## Detailed Site Plan Departure of Parking and Loading Standards The Cassidy

**DSP-21045**  
**DPLS-22002**

SUBJECT:      Detailed Site Plan DSP-21045  
                 Departure of Parking and Loading Standards DPLS-22022  
                 Type II Tree Conservation Plan TCPH-077-04-03  
                 The Cassidy

**Figure 1: Site Plan**

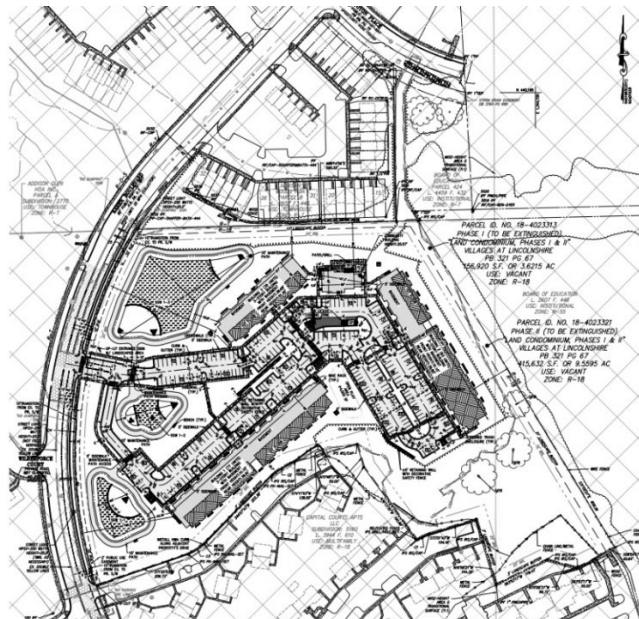
6. **Design Features:** The proposed application is for development of 175 multifamily units within 3 buildings. Each building will be 4 stories and approximately 51 feet tall at its highest elevation. The site will be accessed from a single entrance along Karen Boulevard. Building 1 will contain a total of 77 dwelling units, Building 2 will contain a total of 63 dwelling units, and Building 3 will contain a total of 35 dwelling units. The clubhouse will be 3,596 square feet and located within Building 3. A total of 263 surface parking spaces are provided and the site will have 1 loading space. A companion Departure from Parking and Loading Standards (DPLS-22002) has been filed in conjunction with this DSP to allow for the reduction in 168 parking spaces. SWM facilities will be provided on-site near the entrance and adjacent to Karen Boulevard.
